Joint Permit Application and Wetland Replacement Plan

**West Ridge Railroad Relocation and Tailings Basin
Progression**

**Prepared for
Northshore Mining Company**

April 2019

Figure M-7

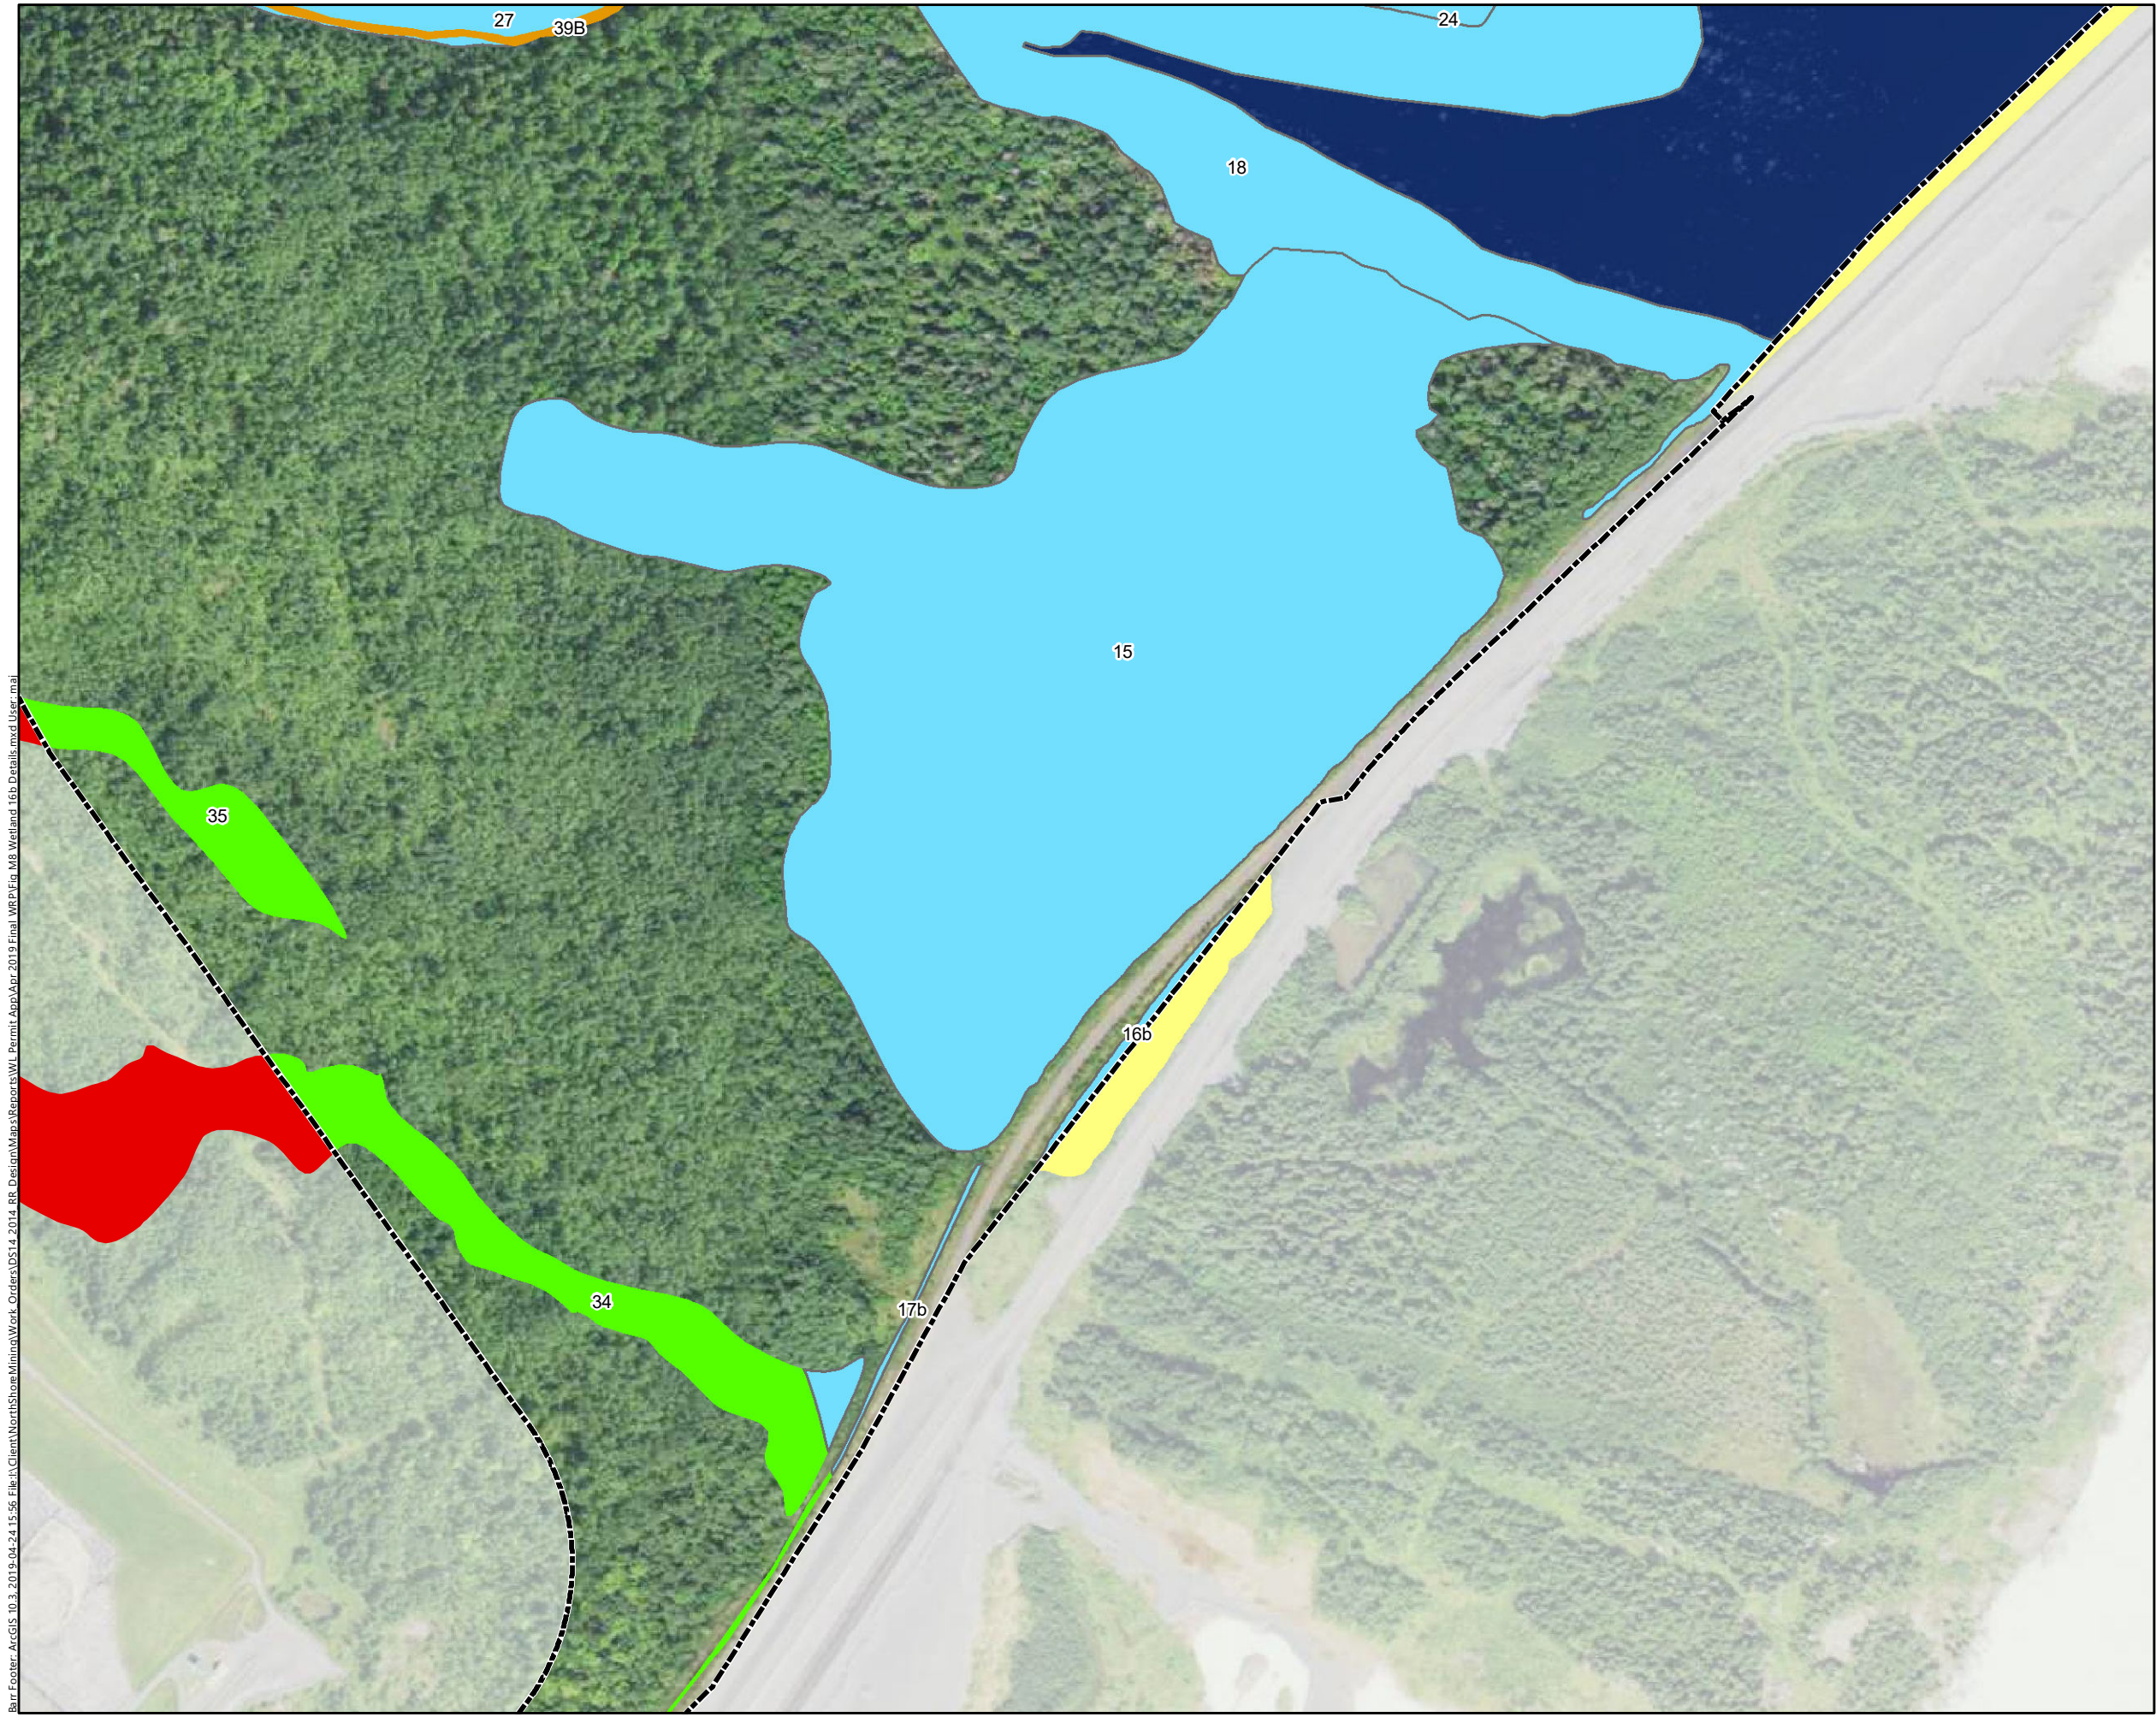
The MnDNR requested additional information showing the size of fragments for Wetland 34 regarding the source of impact as "Railroad and Dam," "Tailings Basin Progression," "Impoundment," or "Unaffected" (Comment 48). Details for Wetland 34 are shown on Figure M-7 (Appendix M) and as further described here. There are three separate pieces of Wetland 34 that will be directly impacted by the railroad or dam with areas of 0.19 ac, 0.74 ac, and 2.83 ac along with 0.19 ac impacted by the tailings basin progression. Because Wetland 34 crosses the landfill area, which is excluded from the project, a 7.53 ac portion of Wetland 34 will be left between the railroad and the tailings basin with no changes to its watershed, so it is expected to remain viable. At the north end of Wetland 34, two fragments are expected to be impounded by the railroad, comprising 1.47 ac along the south side of the railroad and 5.46 ac along the north side (Figure M-7, Appendix M).
